MONITORING YEAR 2 ANNUAL REPORT

KEY MILL MITIGATION SITE

Surry County, NC
NCDEQ Contract No. 7180
DMS Project No. 100025
USACE Action ID No. SAW-2017-01504
NCDEQ DWR Certification No. 17-1045
RFP #: 16-006993

RE: Final MY2 Report Review
Key Mill Mitigation Site, Surry County
Yadkin River Basin – HUC 03040101
DMS Project ID No. 100025 / DEQ Contract #7180

Figure 3.1 Current Condition Plan View Map
 Key Mill Mitigation Site
 DMS Project No. 100025
 Monitoring Year 2 - 2021
 Surry County, NC

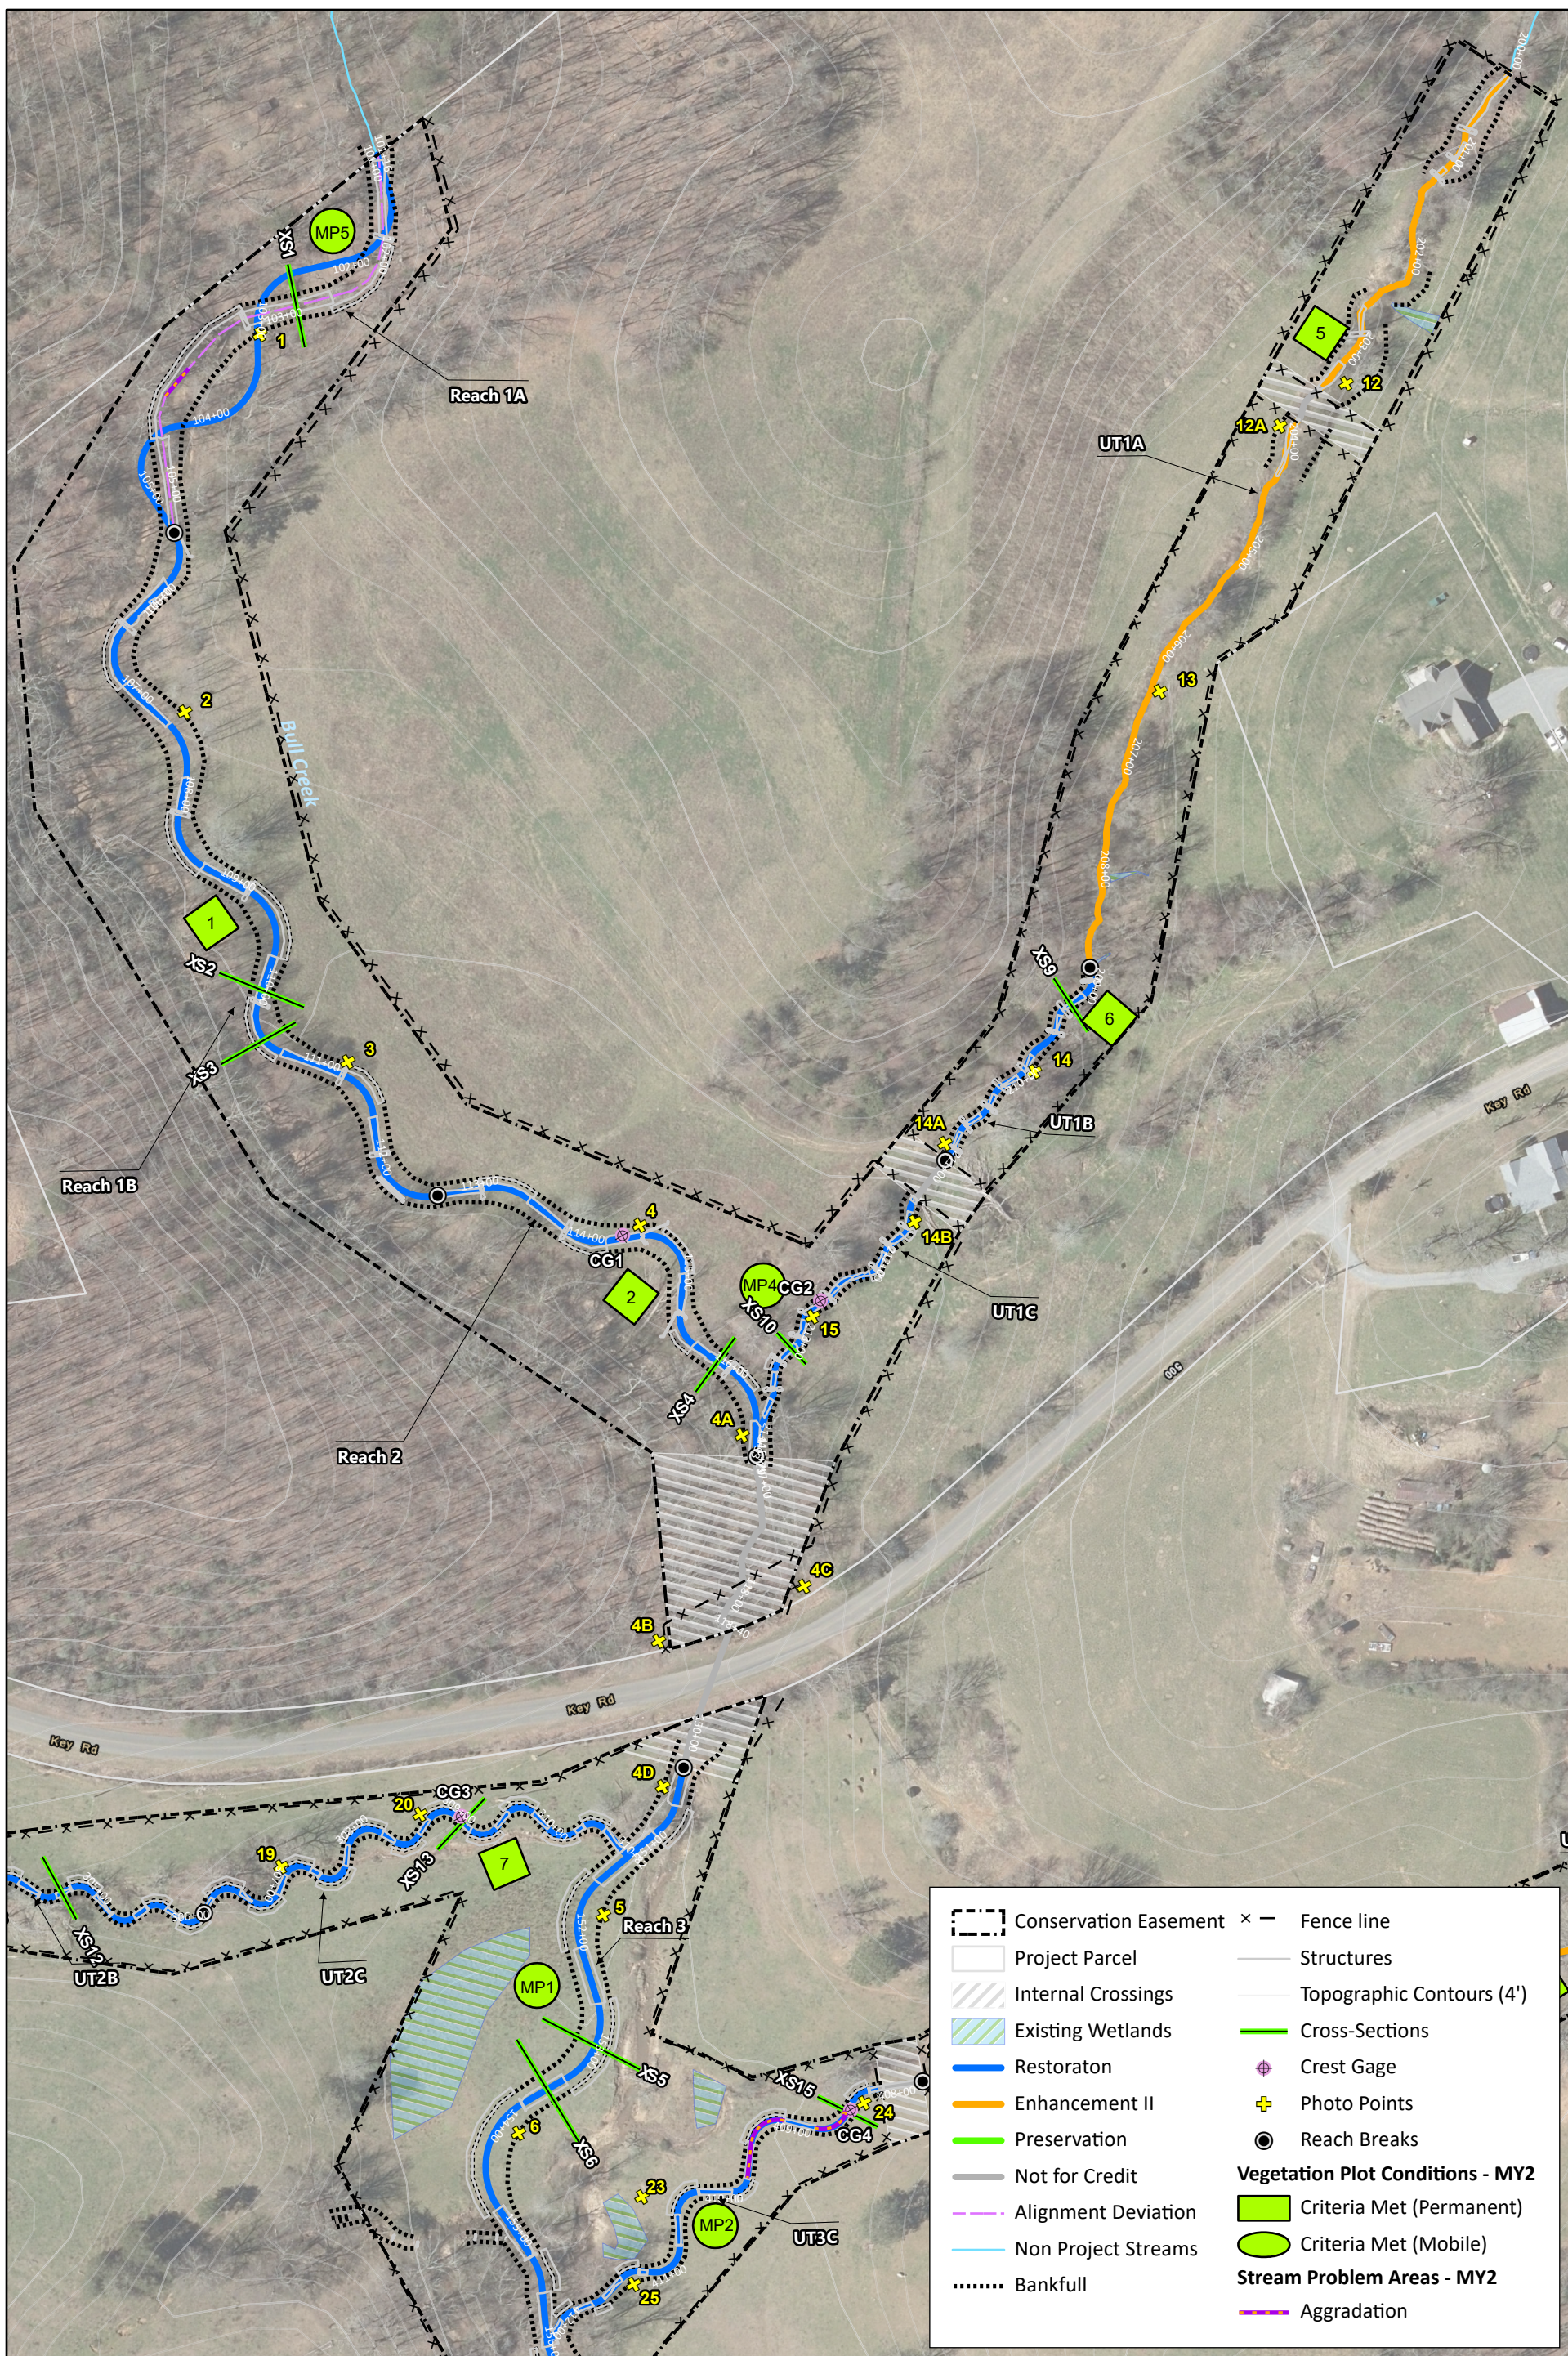
DMS comment: Table 6d: Table shows 1 section or degradation, but it does not occur on the CCPV. Also, the piping structure identified on the site is located on this reach and is shown on the CCPV, but

this structure is not accounted for on the table. Please review and revise the table and CCPV as necessary.

Wildlands' response: The degradation and the piping structure are referring to the same thing and were inadvertently depicted as two different issues. Therefore, the structure shown on the CCPV map was changed to a line in the CCPV map to correctly reflect a length of degradation.

Figure 3.3 Current Conditions Plan View Map
 Key Mill Mitigation Site
 DMS Project No. 100025
 Monitoring Year 2 - 2021
 Surry County, NC

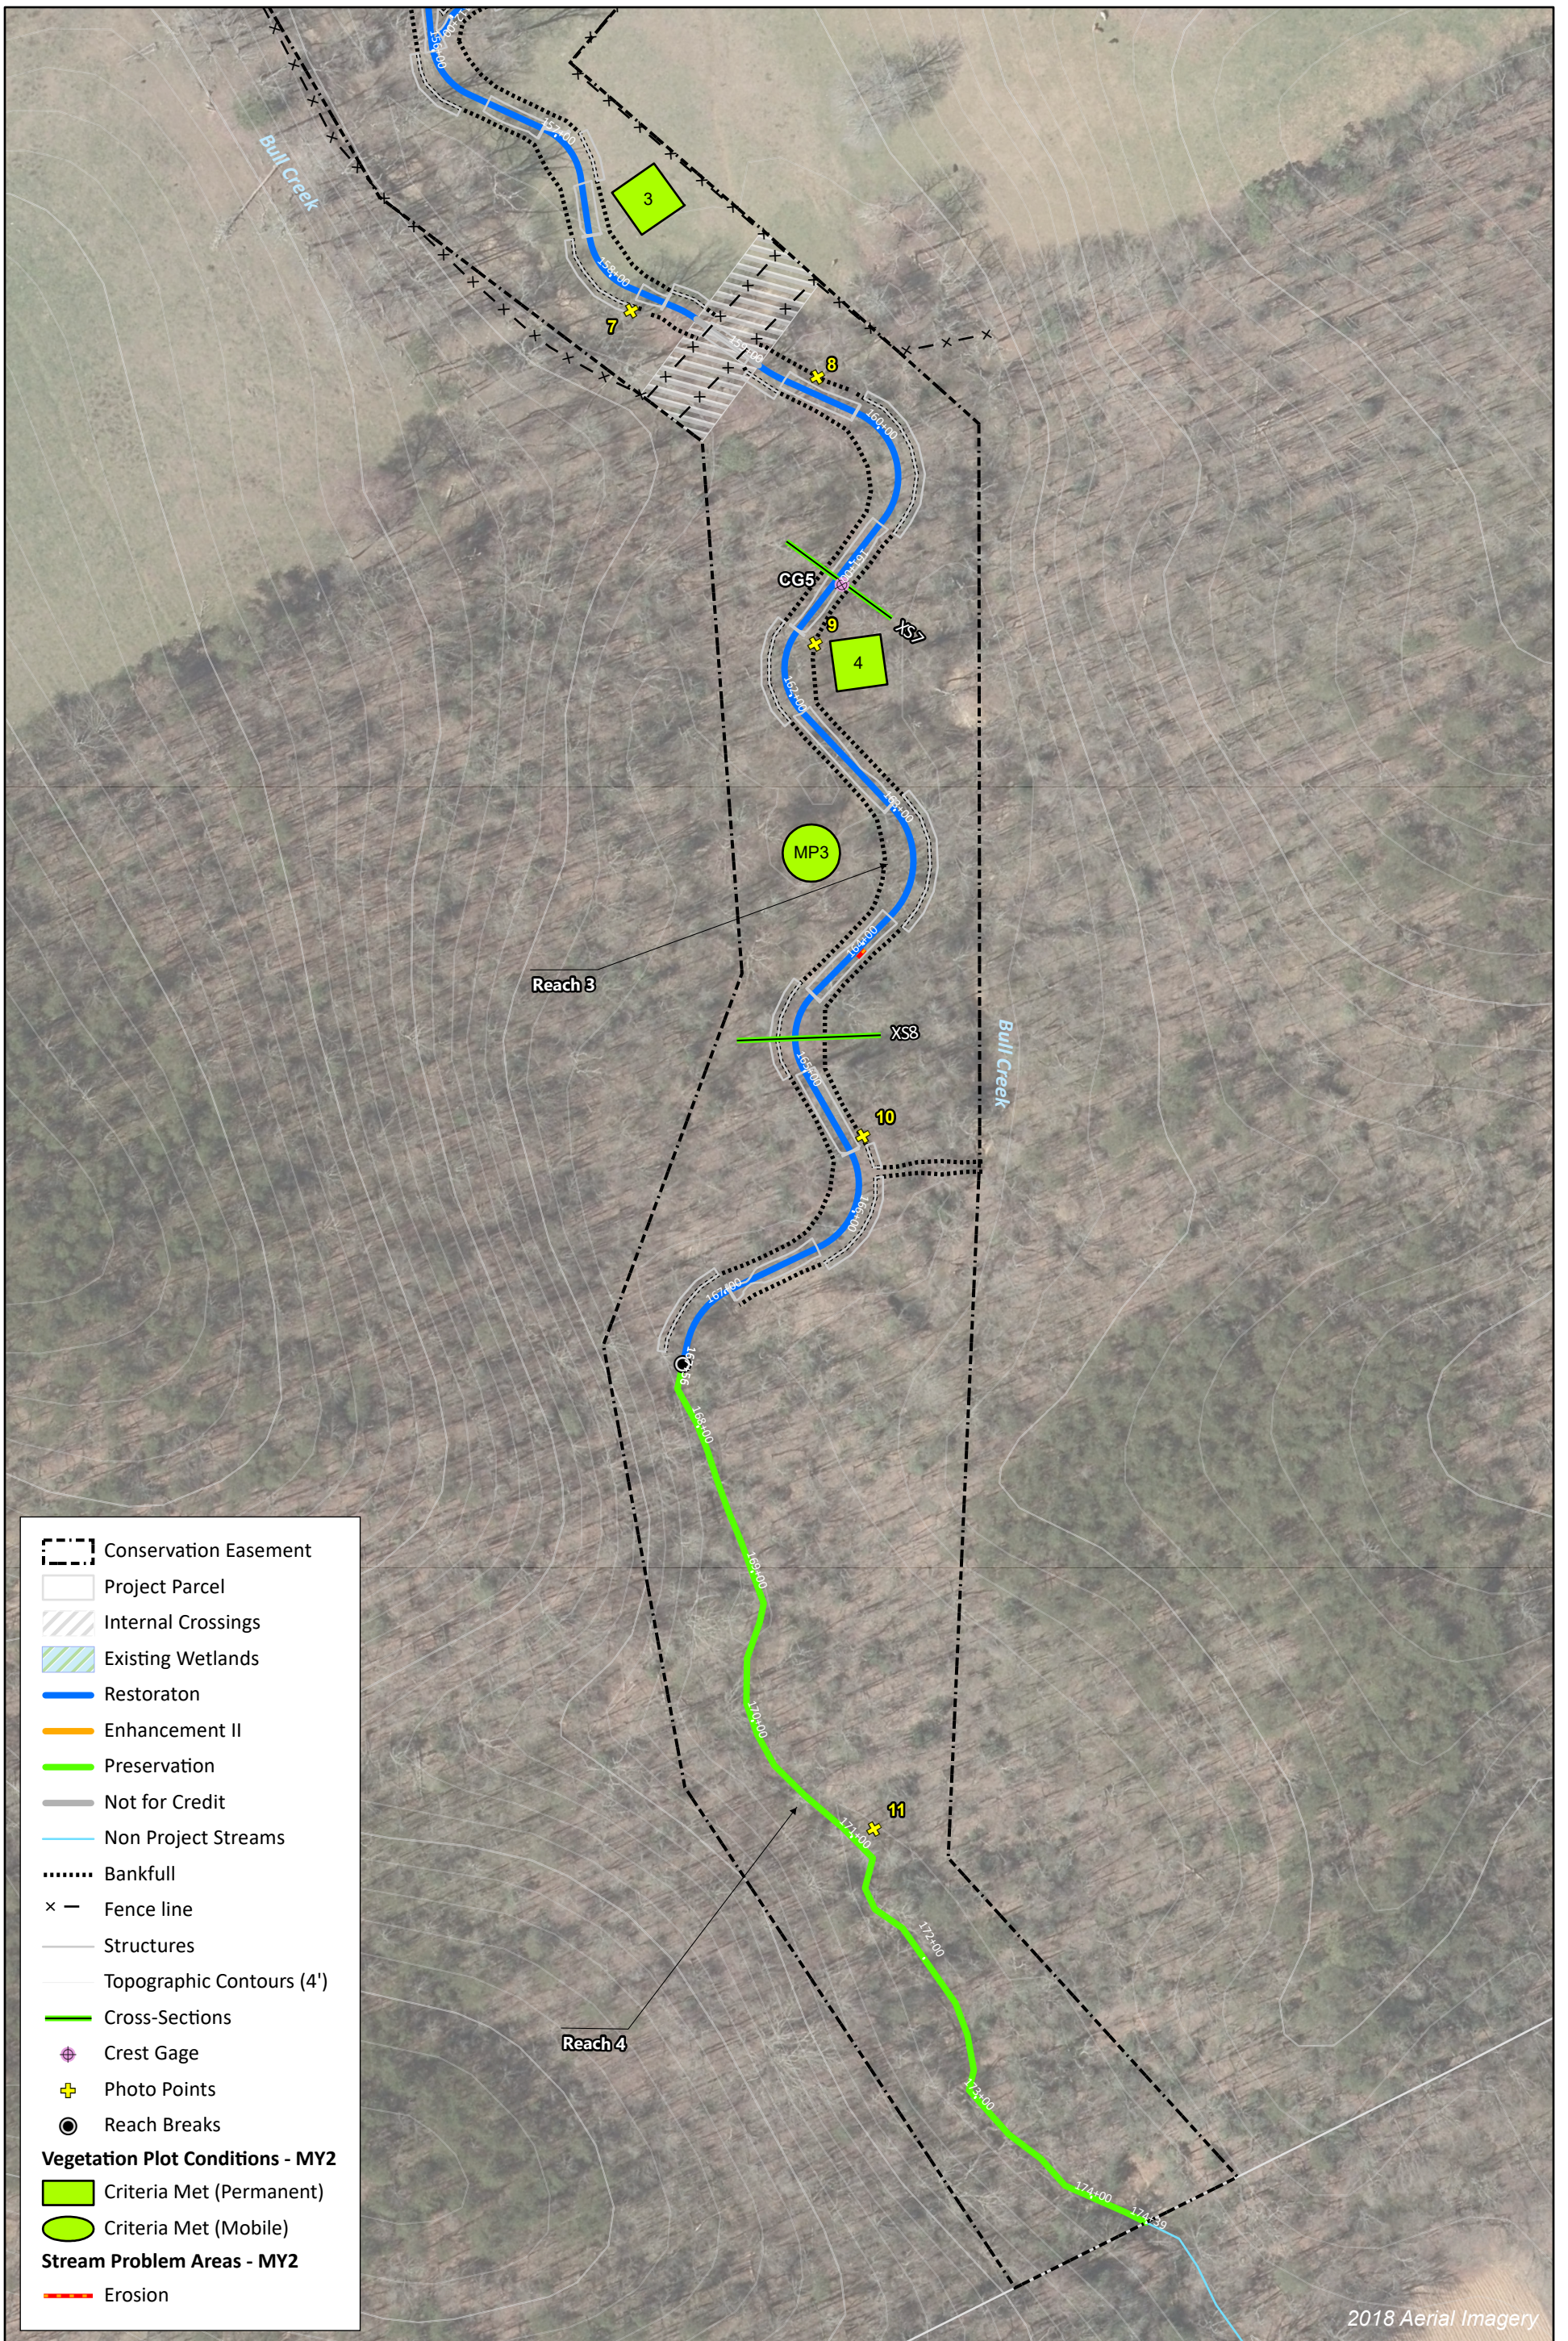
DMS comment: Please include a feature representing the 7 feet of degradation along Bull Creek Reach 3.

Wildlands' response: Wildlands has included the line feature representing the 7 feet of degradation along Bull Creek Reach 3.
